TITLE: CHANGE OF ZONE NO. 05002A, an amendment to THE LINKS AT LINCOLN PLANNED UNIT DEVELOPMENT, requested by The Links at Lincoln, on property generally located at North 1st Street and Fletcher Avenue.

LINCOLN/LANCASTER COUNTY PLANNING STAFF REPORT

PROJECT #: Annexation #06009
Change of Zone No.05002A, The Links at Lincoln PUD

Review Comments for
Application #: CZ05002A
THE LINKS AT LINCOLN

SITE PLAN

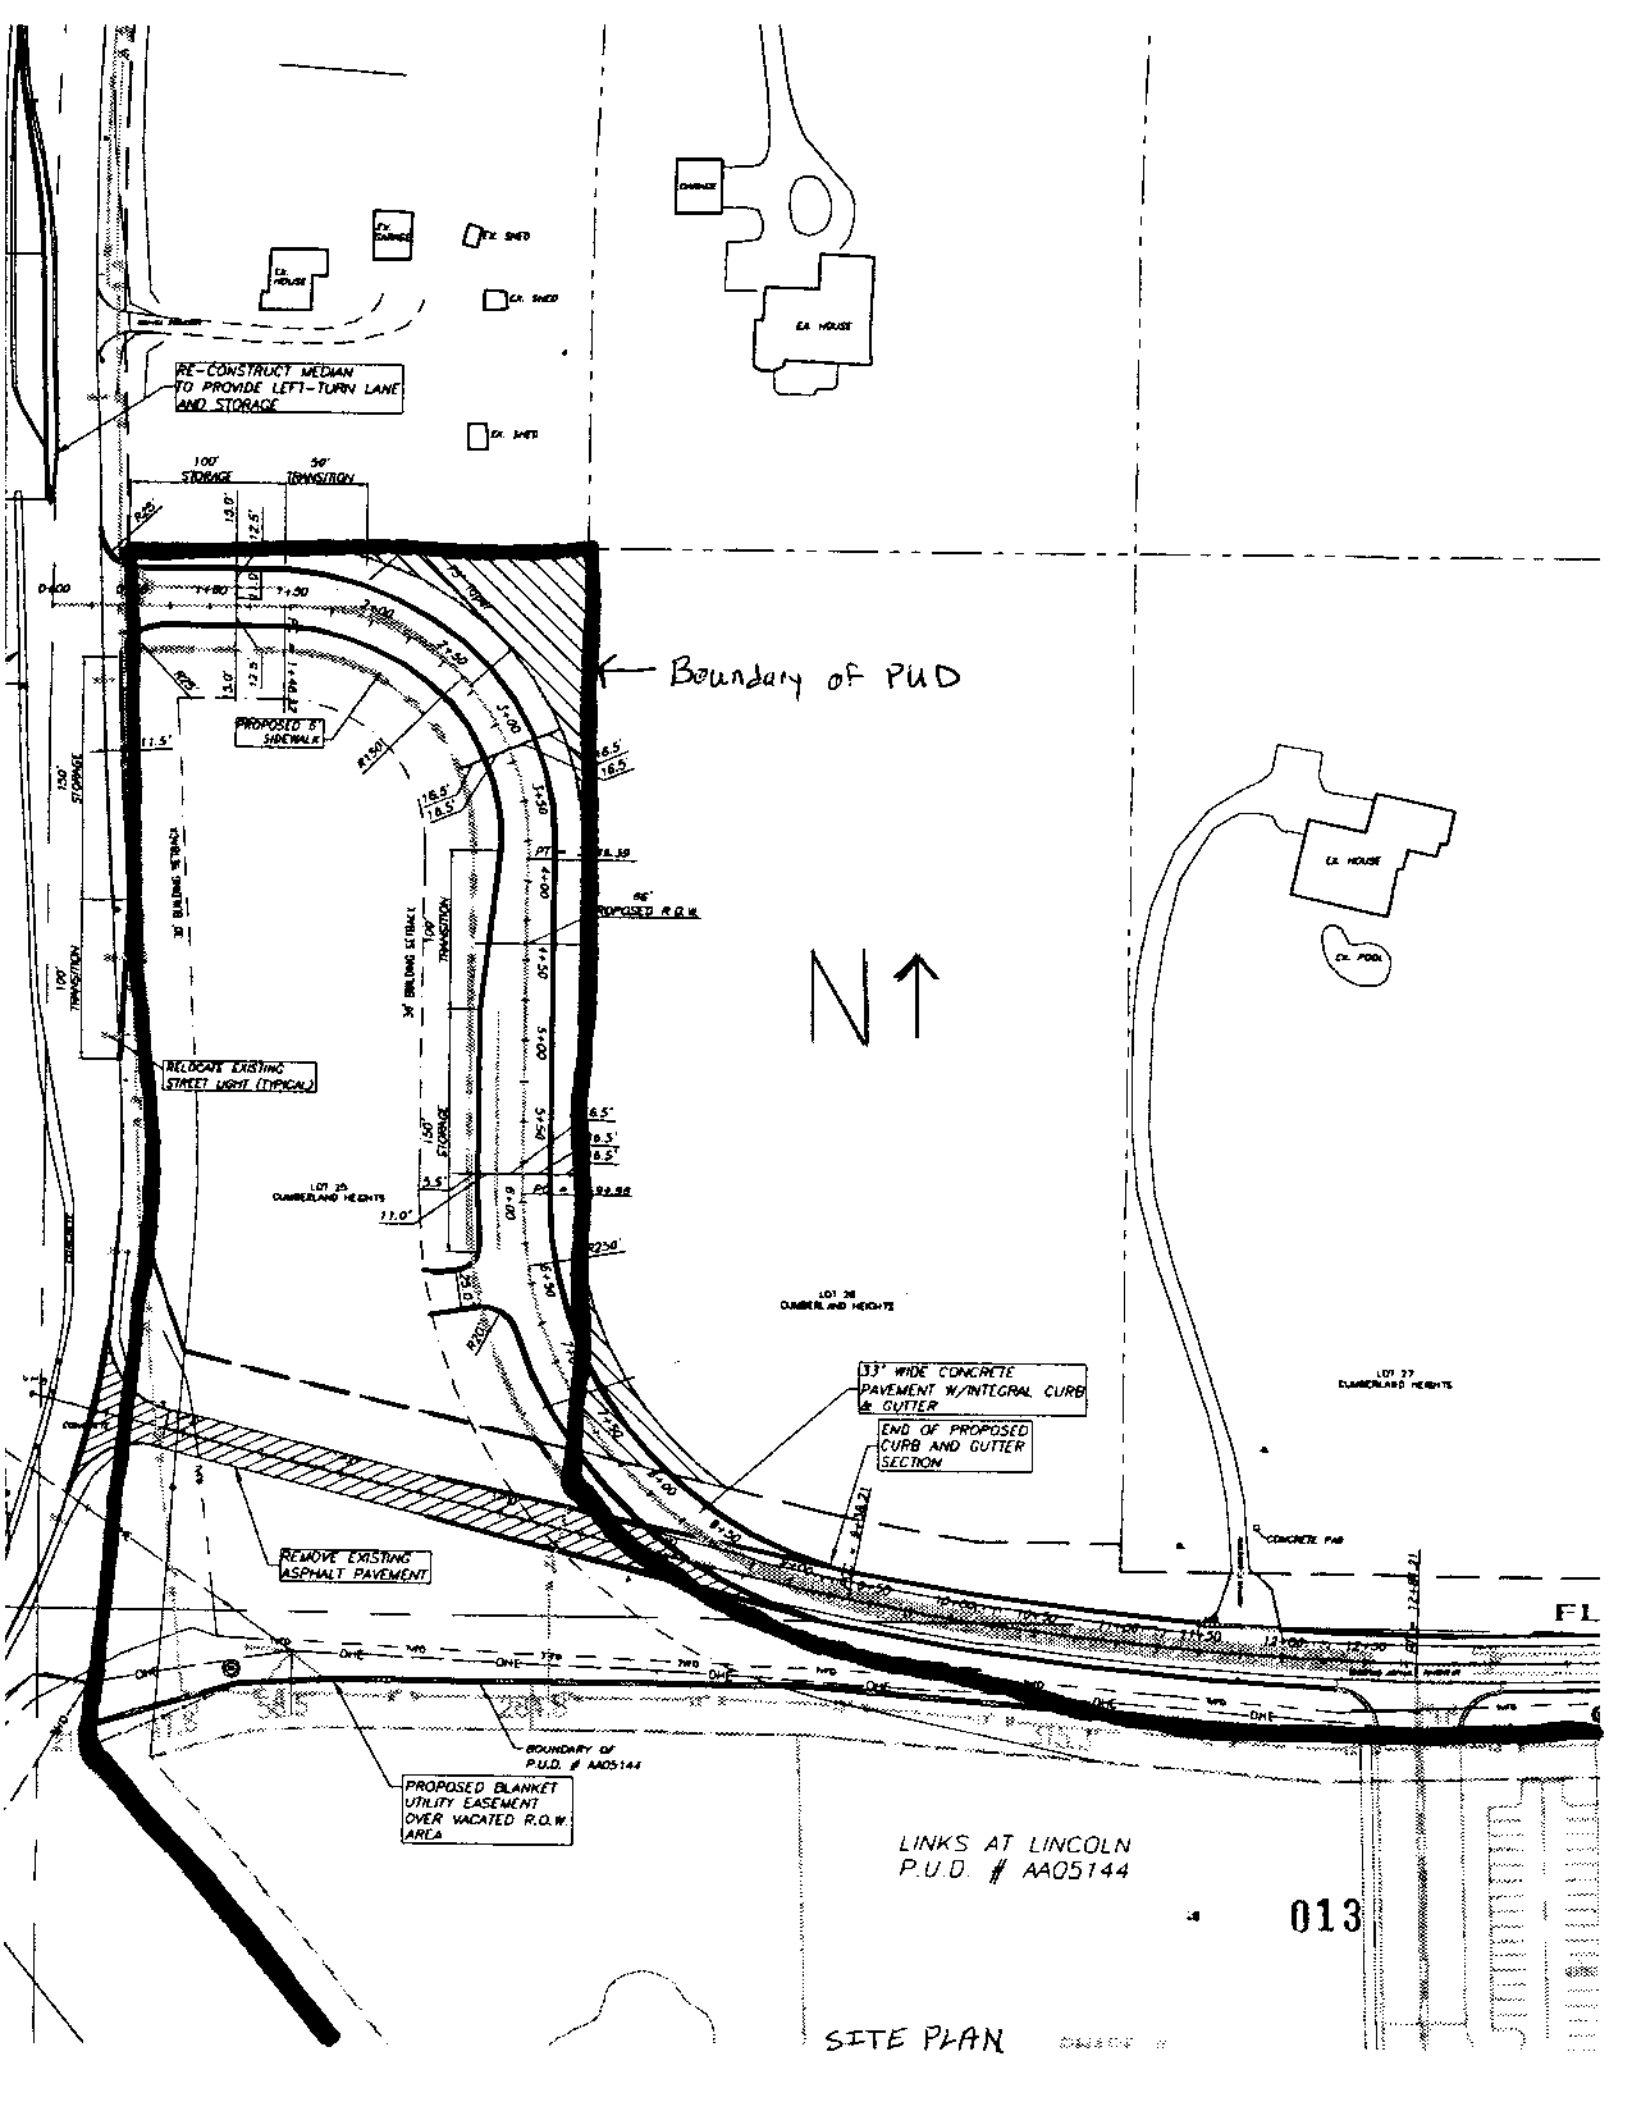
- 4.1.1.1 Revise the boundary of the PUD to include all of Lot 25, Cumberland Heights. Use the same line type for the entire boundary.
- 4.1.1.2 Add a note stating that the portion of Fletcher Ave. outside the boundary of the PUD shall be deeded to the City at no cost for street right-of-way purpose.
- 4.1.1.3 Show fire hydrants on the utility plan.
- 4.1.1.4 Remove the parking, building layout and Lot 25 Cumberland Heights from all sheets.

- 4.1.1.5 Show the crosshatched area in the northeast corner as an outlet.
- 4.1.1.6 Show the area bounded by N. 1st St., Fletcher Ave. and vacated Fletcher Ave. as Lot 1.

- 4.1.1.7 Show vacated Fletcher Ave. as an outlet. Show a blanket utility easement over the outlet.
- 4.1.1.8 Dimension the lots and outlots.
- 4.1.1.9 Add a note to the General Notes that permitted uses under the R-3 district shall be allowed on Lot 1.

- 4.1.1.13 Show the General Lot information and Development Area information from AA #05144 on the cover sheet.
- 4.1.1.14 Remove the bold dash line of vacated Fletcher Ave. The removal of this line will help clarify the boundary of the PUD.

- 4.1.1.15 Change the building front yard setback to 20 feet.
- 4.1.1.16 Label the existing right-of-way along N. 1st Street on Sheet C1.1.
- 4.1.1.17 Change Lots 38, 53 and 58 I.T. to Lot 1, The Links at Lincoln in the legal description. The legal description must be signed by a licensed surveyor.

- 4.1.1.18 Update the legal description of the addition to the PUD to include all of Lot 25, Cumberland Heights.
- 4.1.1.19 Show a blanket utility easement excluding building envelopes over the addition to the PUD.

- 4.1.1.20 Change proposed use on Sheet C0.0 to R-3. Delete "commercial".
- 4.1.1.21 Make corrections to the satisfaction of Public Works and Utilities Department Watershed Management per their memo of May 11, 2005.

Comments: Label uses for commercial area of PUD

Comments: no fire hydrants shown utility plan

- 1 The proposed 8" sanitary sewer shown in the proposed realigned Fletcher Avenue needs to be revised to be shown in the standard location outside the back of curb adjacent to the proposed turn lane.
- 2 The plans reference 33' wide paving for the realigned Fletcher Avenue. This dimension will represent the face of curb to face of curb dimension. The total paving width, from back of curb to back of curb will need to be shown as the 34' section as shown in LSP-640 of the City of Lincoln Standard Plans.
- 3 The cover sheet references 5' sidewalks while the detail sheet indicates 6' wide sidewalks. The discrepancy needs to be addressed.
- 4 The proposed water main in the realigned Fletcher needs to be revised to connect to the 16" shown in the south side of Fletcher instead of the 24" planned for the north side of the street.
